Technical Service Information

THM 4T80E **SLIPS IN FOURTH OR NO FOURTH**

Figure 1

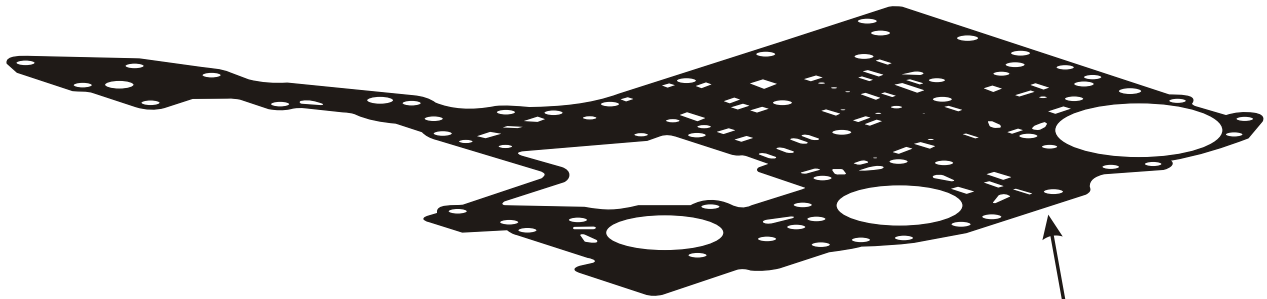
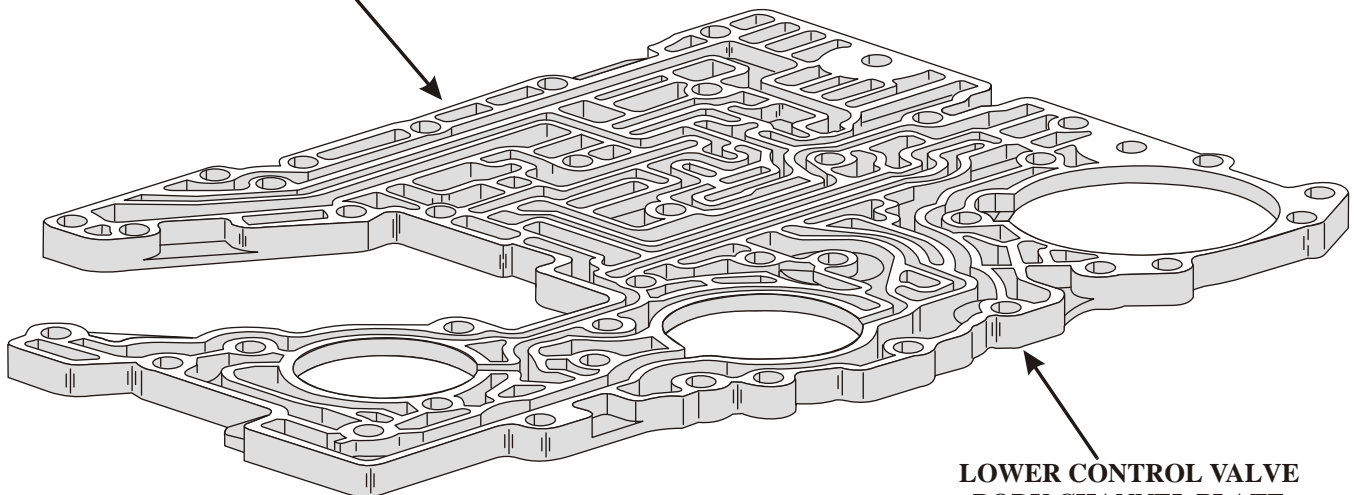
CAUSE: This complaint may be caused by a warped lower control valve body channel plate, shown in Figure 1. The warped channel plate creates a loss of fourth band apply pressure resulting in damage the fourth band and the reverse clutch housing.

**CHANNEL PLATE WARPS,
CHECK WITH STRAIGHT EDGE**

CORRECTION: Inspect the fourth band and the reverse clutch housing and replace them as necessary. Replace the lower control valve body channel plate, spacer plate and gasket, using the OEM part numbers shown below..

REPLACE "ALL" ITEMS SHOWN
